Project
PROPOSED DEVELOPMENT AT
BALTONSBOROUGH
GLASTONBURY
SOMERSET

Drawing Title
Plots 37-41 Proposed Elevations

Scale	Date	Drawn	Chk'd
1 : 100 @ A2	Aug 2022	MG	MP
DWG No.	4424-37-41-P02		Rev.
			-

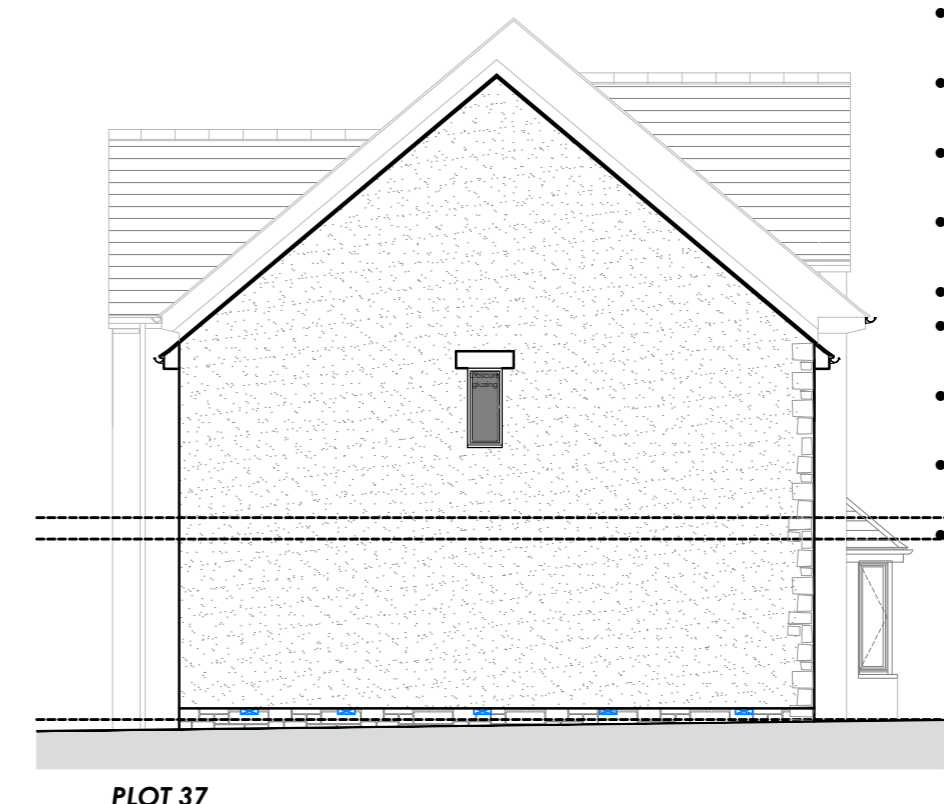
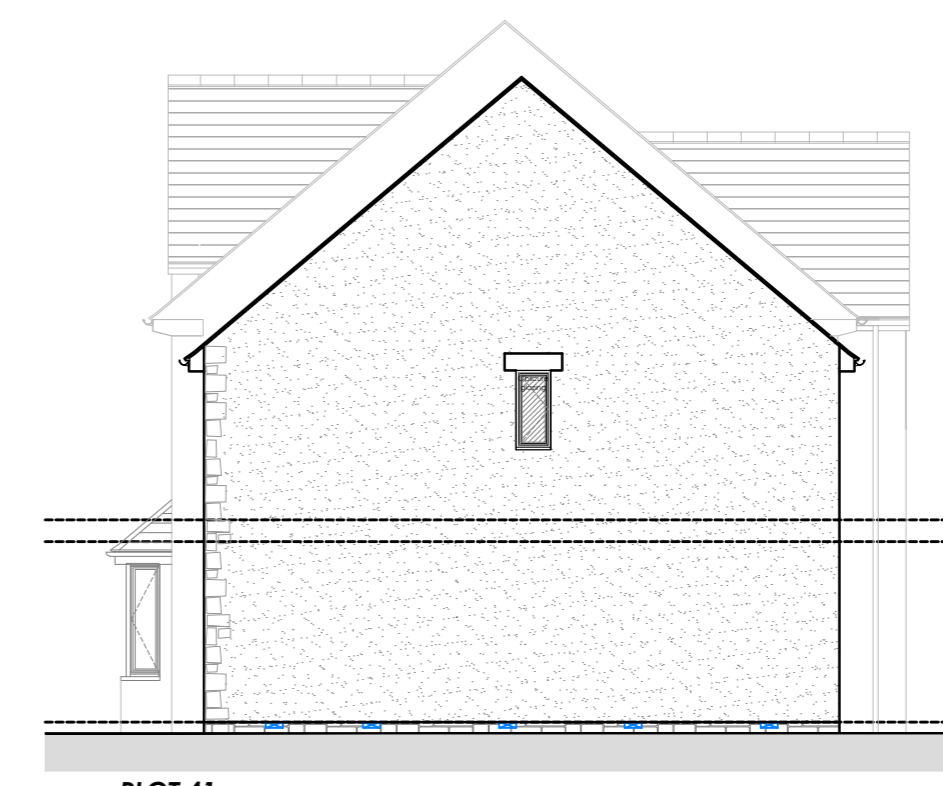
- North elevation plots 37, 38, 40 & 41 changed from brick/ render to natural stone.
- Front elevation porches changed from pitched roof to lean to canopies.
- Brick arches omitted & replaced with natural stone lintels.
- East & West elevation ground floor windows omitted.
- Plots 37 & 38 dormers above windows omitted. Eaves raised to match Plots 40 & 41
- South Elevation Plots 40 & 41 changed from brickwork to render.
- Plot 39 quoins omitted & replaced with natural stone.
- Front elevation front door sidelights omitted.
- Water tabling to Plot 39 omitted.
